- Minor Amendment:
- Site Plan:
    - Revise parking at west site to head in and add 6 stalls.
    - Increase width of drive aisle from 24'-6" to 26'-0".
    - Adjust location of pedestrian crosswalk at north end of site and paint 4" wide strips at 45 degrees 2'-0" o.c.

PROJECT NUMBER: PR-2021-005473

Application Number: SI-2021-00709

## LADERA BUSINESS PARK UNIT 1 - CACTUS PATCH PLAZA

A1 SITE PLAN  
1" = 30'-0"

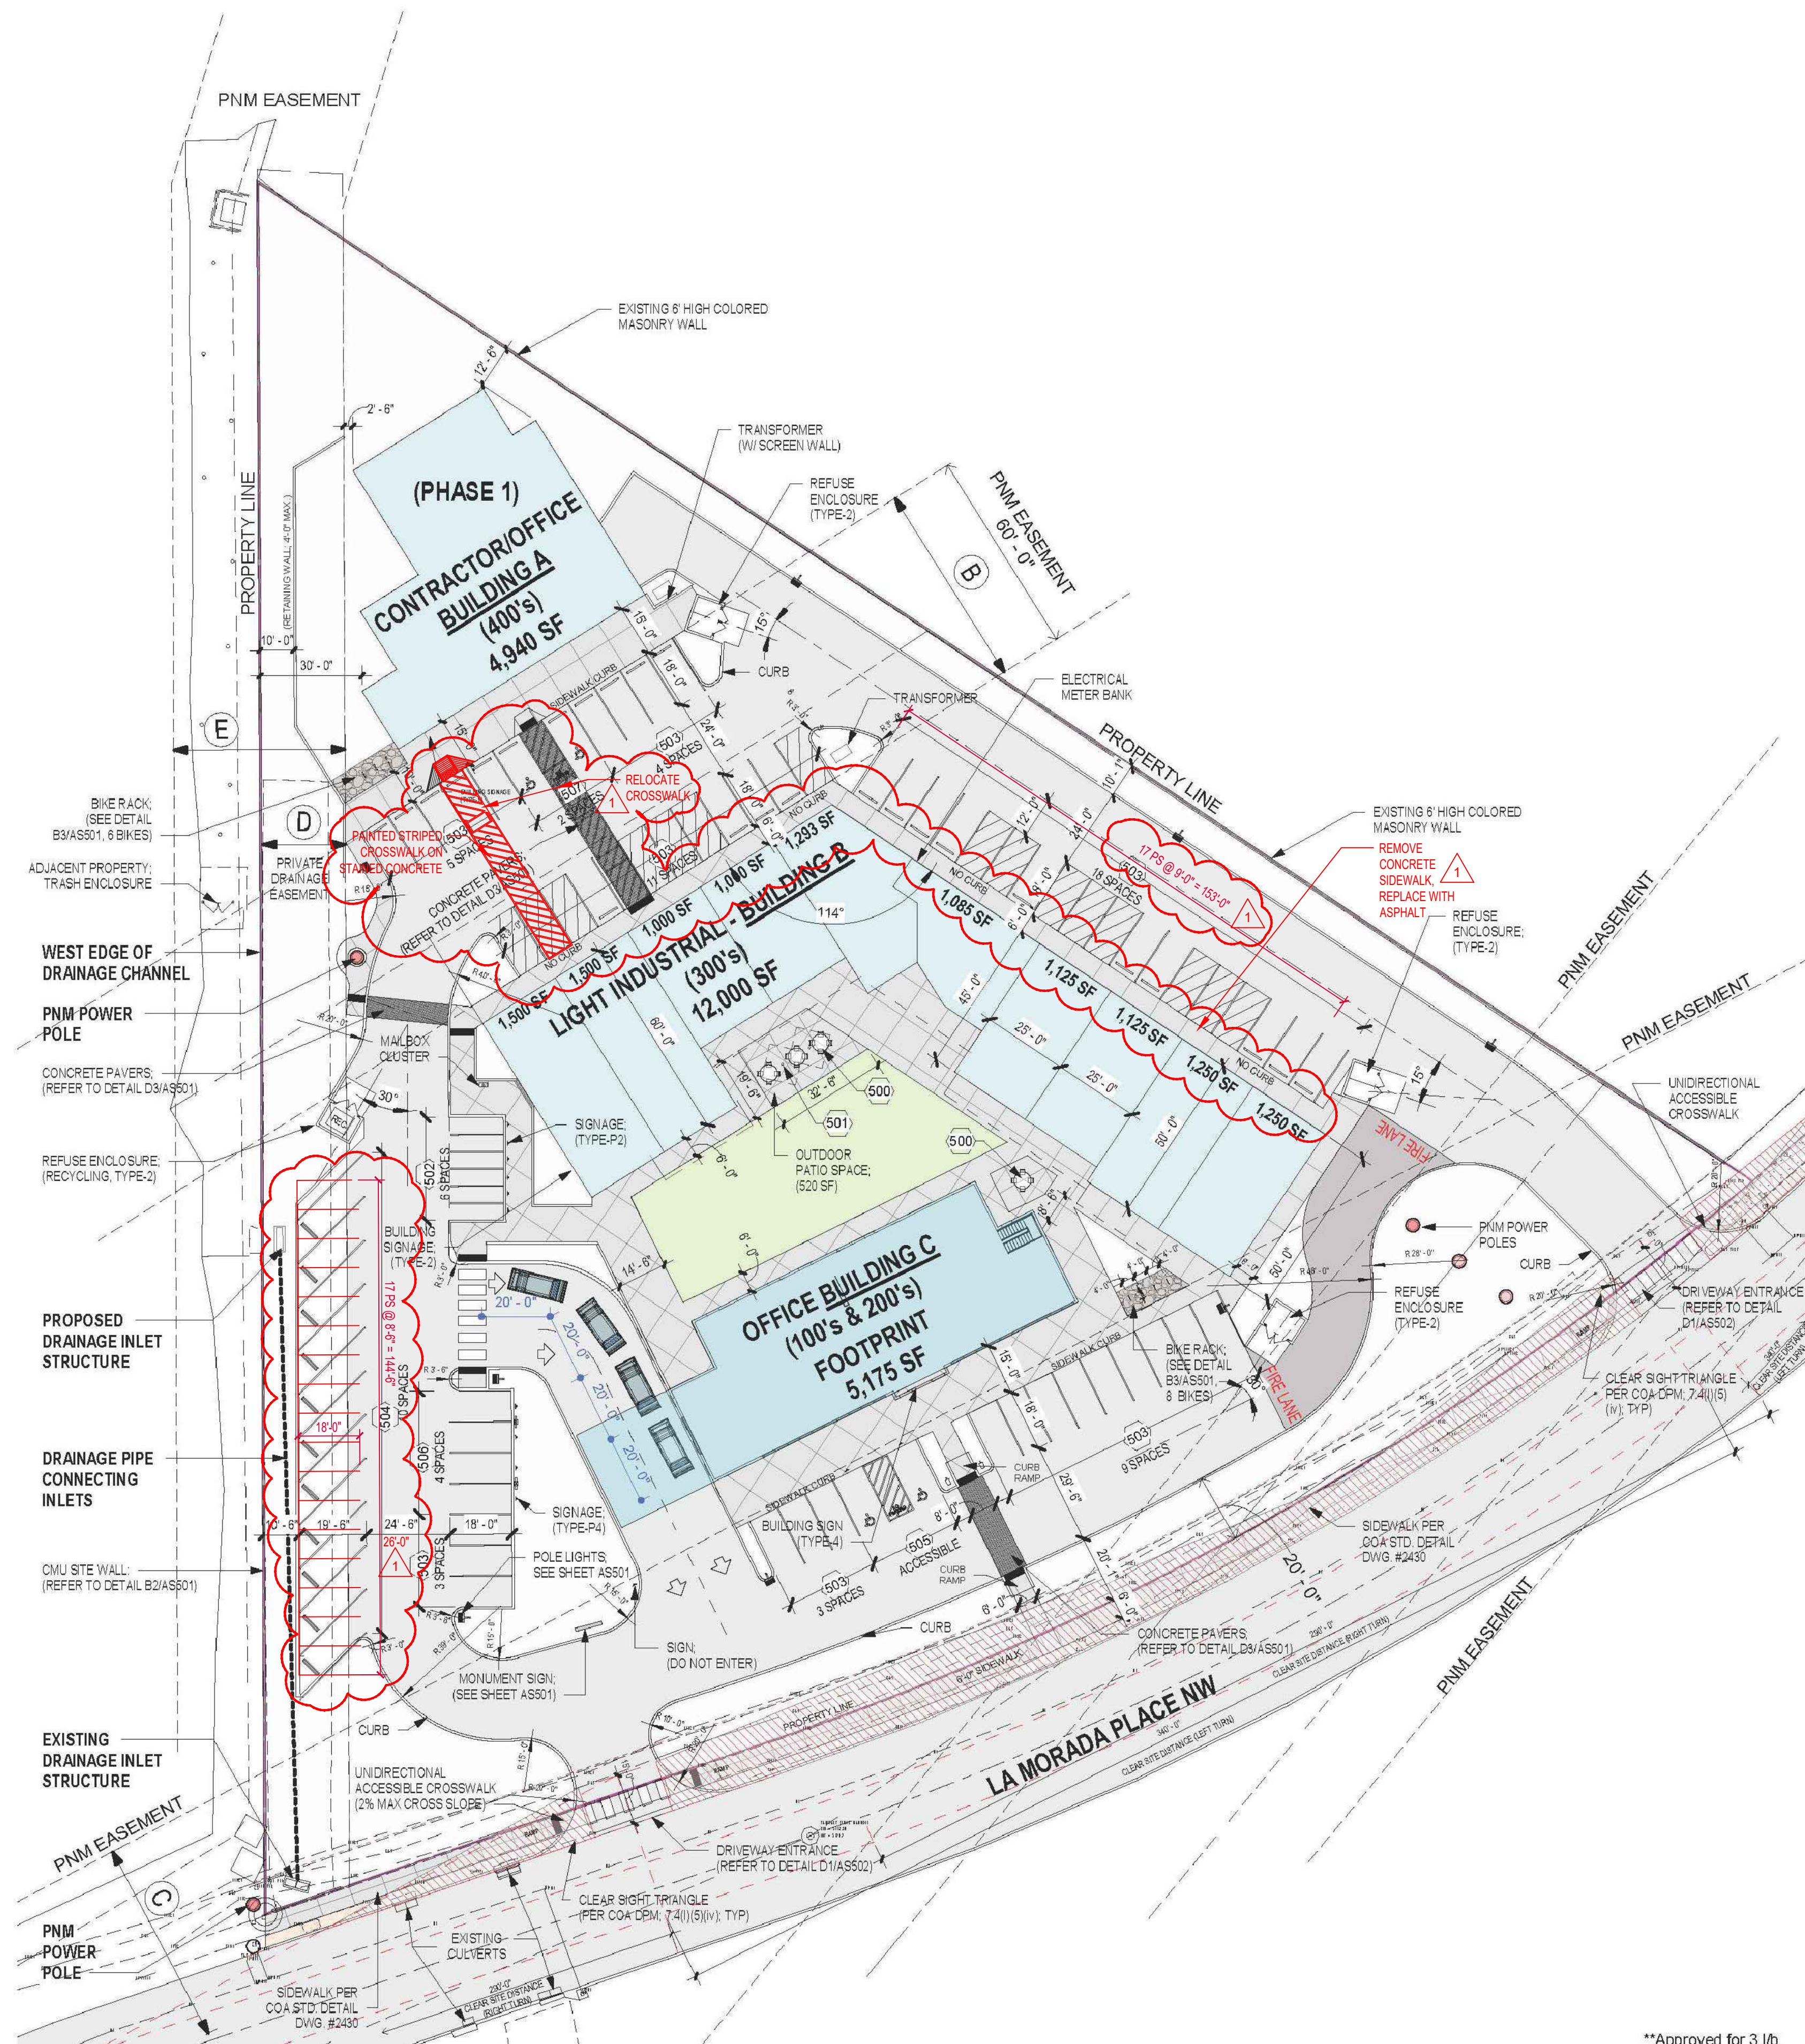
- Eliminate concrete sidewalk at north and east side of building B.
    - Reduce parking stalls at east side of site from 18 to 17 to allow for actual size requirement of trash enclosure.

- Revise total parking count from 72 stalls to 77 total stalls.
    - Eliminate all phasing for project and to install landscaping.
  - Building A Elevations:

# BLDG A - EXTERIOR ELEVATIONS

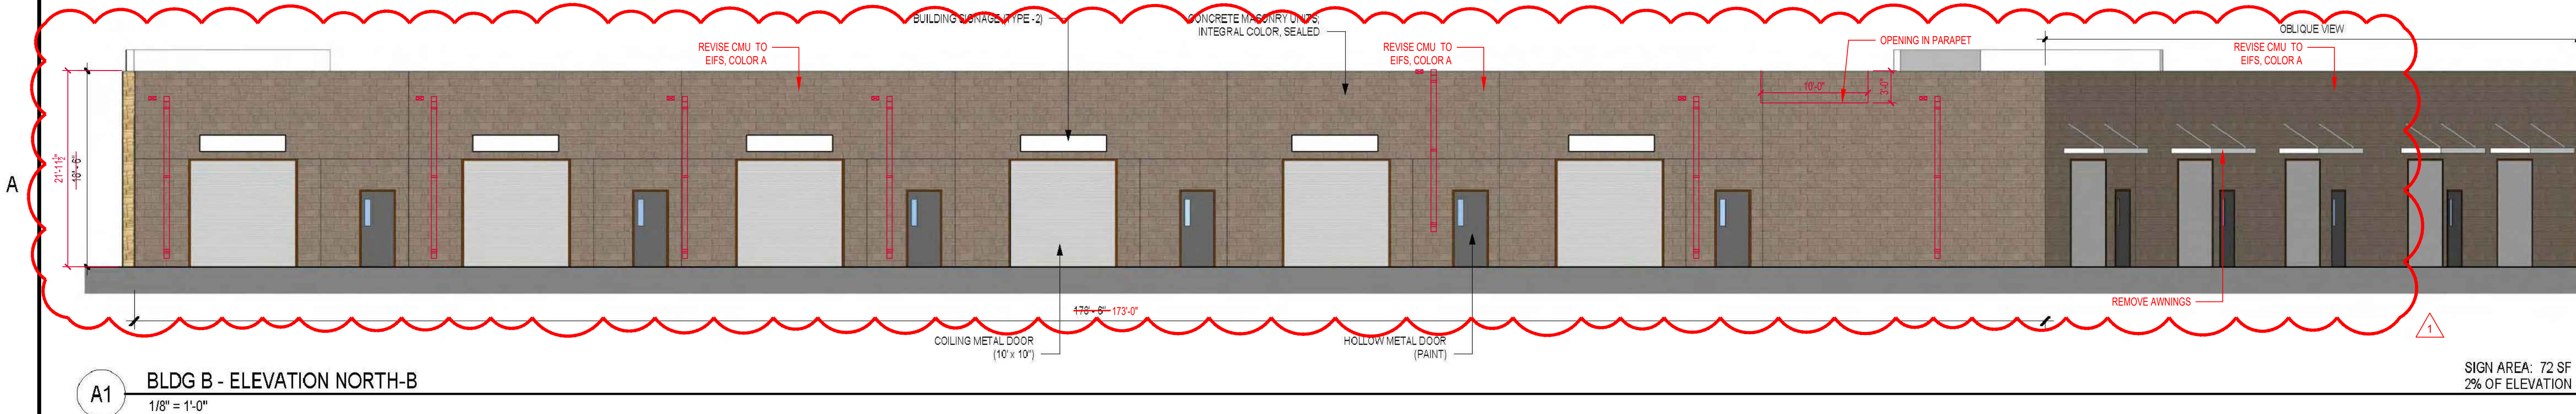
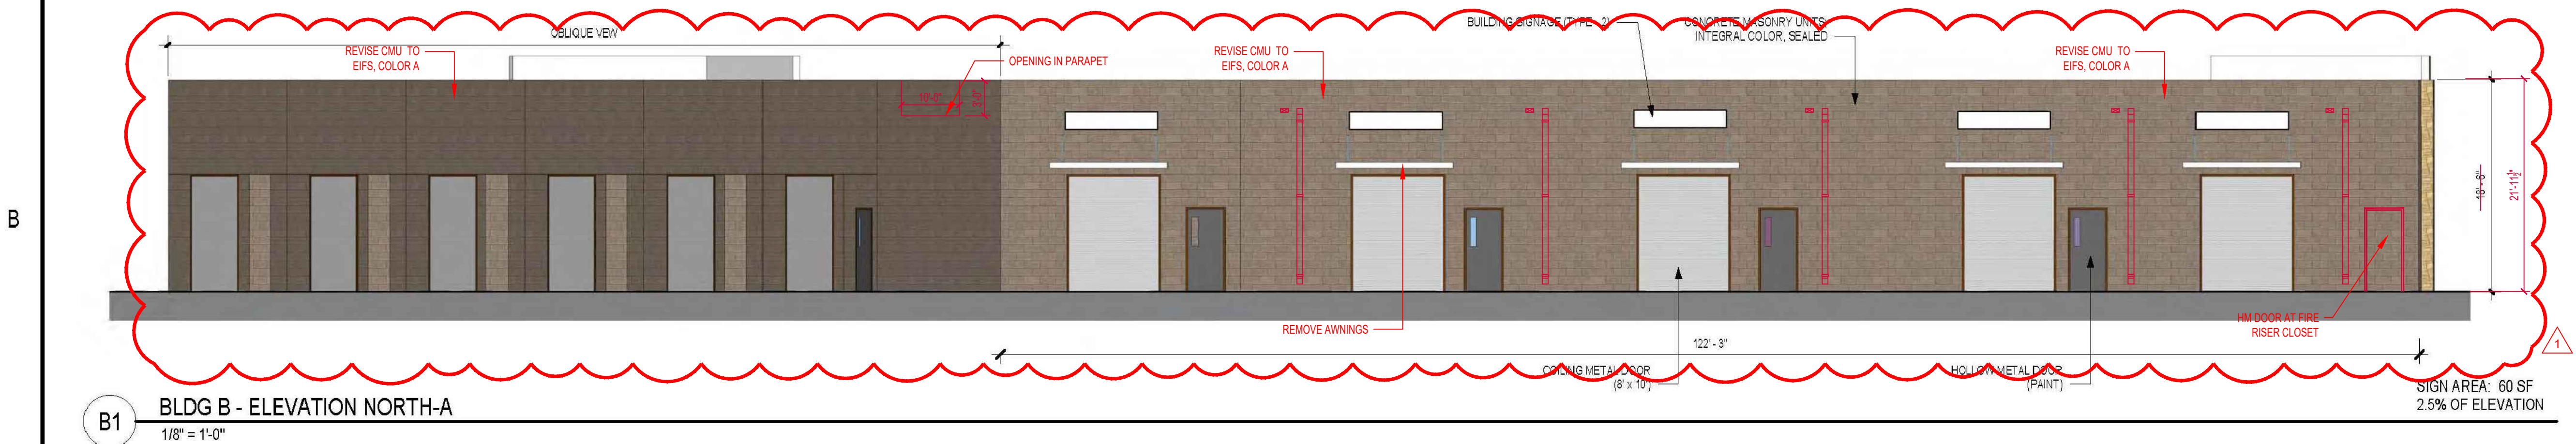
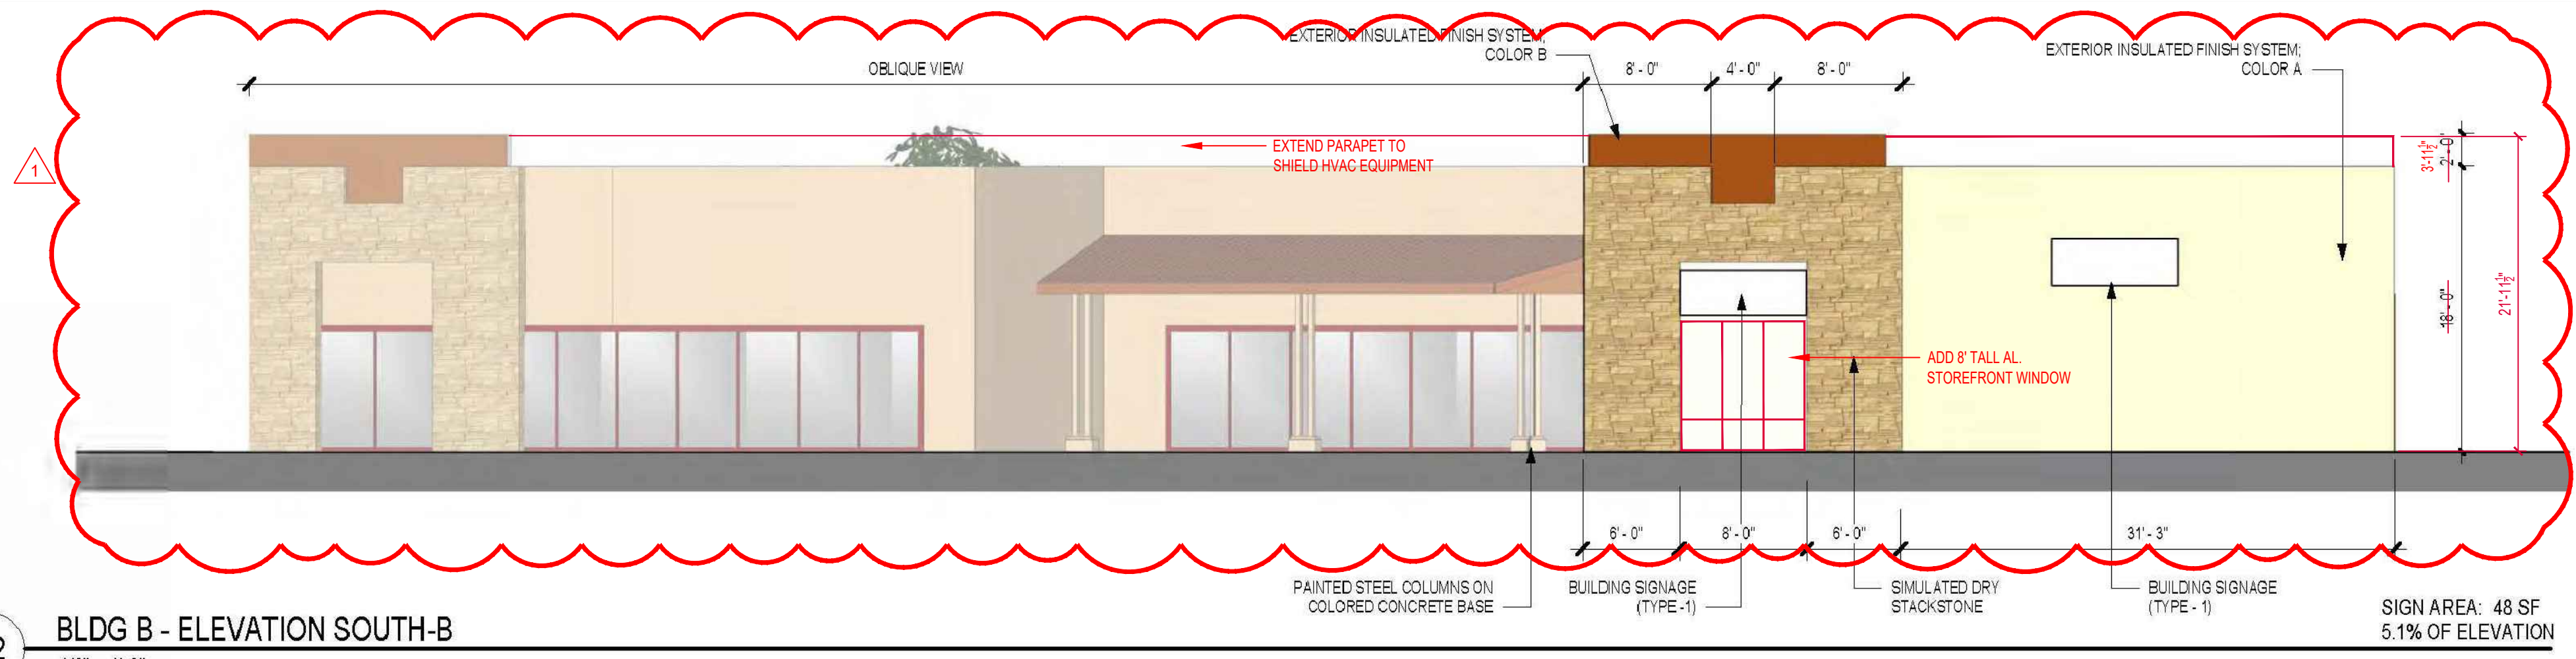
- Increase building height from 21'-0" to 23'-1" to provide HVAC screening.
    - Add 3'x10' opening in parapet for access for HVAC installation to avoid overhead power lines.

EXTEND PARAPET TO  
SHIELD HVAC EQUIPMENT

REVISE WINDOW LAYOUT

REVISE WINDOW LAYOUT
